Product Change Notification

January, 2012

Bourns® Trimpot® Product Line Announces Product Change for Model 7813

Current Model

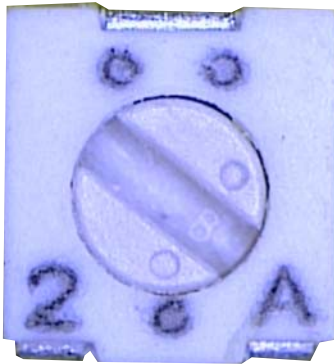
Bourns® Trimpot® Product Line has updated the housing material for the Bourns® Model 7813. This improved housing material is now halogen free**. There is no change to form (except color), fit or function. The halogen free material will come in a black color. A benefit of this color change is an enhanced contrast in marking.

New Halogen Free Model

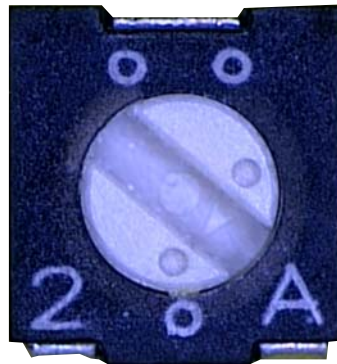
We will begin phasing in this material on April 1, 2012.

- The effective date code will read 2E.
- The expected last date of manufacture of the current product is April 15, 2012.
